Author's response for Ref: egusphere-2025-377

Ref. No.: egusphere-2025-377
Title: Isotopic signatures of methane emission from oil and natural gas plants in southwestern China.

Journal: Atmospheric Chemistry and Physics.
Authors: Dingxi Chen, Yi Liu, Zetong Niu, Ao Wang, Pius Otwil, Yuanyuan Huang, Zhongcong Sun, Xiaobing Pang, Liyang Zhan, and Longfei Yu.

Fig.1 Methane Isotopic Analysis Procedure for Gas Samples

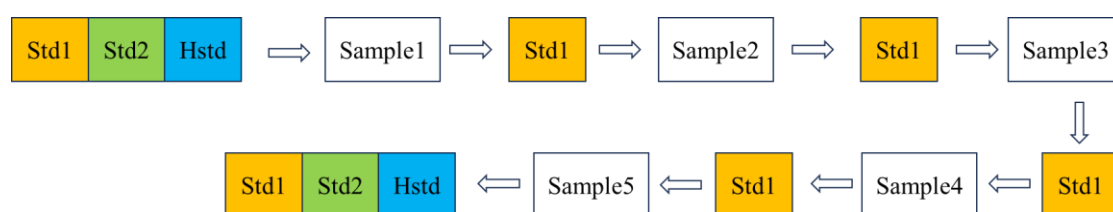
1. **This manuscript presents new methane isotopic data for Chinese oil and gas infrastructure measured on a CRDS instrument. It concludes that it can distinguish between sources. Unfortunately, the data presented can only imply what the averaged fossil fuel signature might be. Overall, the data shown are not convincing because: a) the emissions categories are not characterized at source, or close to individual emission points, and b) the source signature calculations mostly have very large errors and rely on a 1-point calibration of raw data.**

Regarding the measurements, we are sorry for the misunderstanding in our dataset and analyses. The CRDS system from Picarro used in our research has been widely applied for measuring CH_4 isotopic signatures from various sources (Menoud et al., 2022; Ars et al., 2024; Al-Shalan et al., 2022; Geum et al., 2024; Rella et al., 2015; Lu et al., 2021). As for the laboratory measuring our samples, the initial calibration was conducted only with 1-point calibration, mainly due to that the G2132-i system is rather stable throughout the time. Actually, we should note that, we have used two international

primary standards (based on VPDB; Std1 and Std2, -68.6‰ and -40.0‰) and one secondary standards (House-standards, Hstd, -46.89‰) which had been cross-calibrated. Along each measurement sequence (see more details as demonstrated in the figure 1), we measure all three standards together with the standards (5 samples for each sequence), during which Std 1 is used for calibration and correction for sequence-drift, Std 2 used for quality control and Hstd used for constraining long-term drift. As for our case, the measurements were finished within less than a week, so we didn't correct for long-term drift. For simplicity consideration, we only adopted Std 1 for calibration (both delta calibration and short-term drift correction). Of course, the short-term drift was minor compared with delta calibration. Nevertheless, we value the comments from reviewer 3, and will recalibration and evaluate our datasets with 2-point calibration scheme. As shown in the figure 2, given the good correlation among all three standards, we believe that our Picarro G2132-i system is rather robust and will not significantly alter our final results and main findings.

Fig.2 Calibration of the instrument was conducted by linear regression between the certified values and measured isotopic values of Std1 and Std2, ensuring accuracy and consistency in $\delta^{13}C$ measurements.

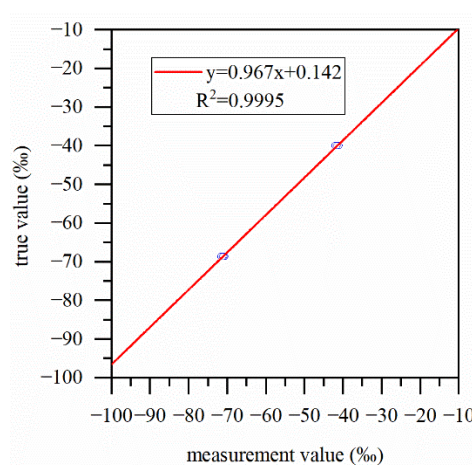
11. Line 216 - you cannot have a 1-point calibration for isotopes, as the isotopic calibration slope is very different for the CRDS between say -70 and -30‰, probably making a difference of about 1‰ for every 10‰ change in measured isotopic value compared to the slope defined by metrology and isotope ratio mass spectrometry. Therefore, if you calibrate at -70‰ you will be then incorrect by 4‰ at -30‰. You need at least 3 calibration points across your range of measured values.

Adjustments have been made in the revised manuscript: Line 202-210.
Adjustments have been made in the revised support information: Page 12-13.
We modified all the data based on two-point calibration and re-plotted the graphs.
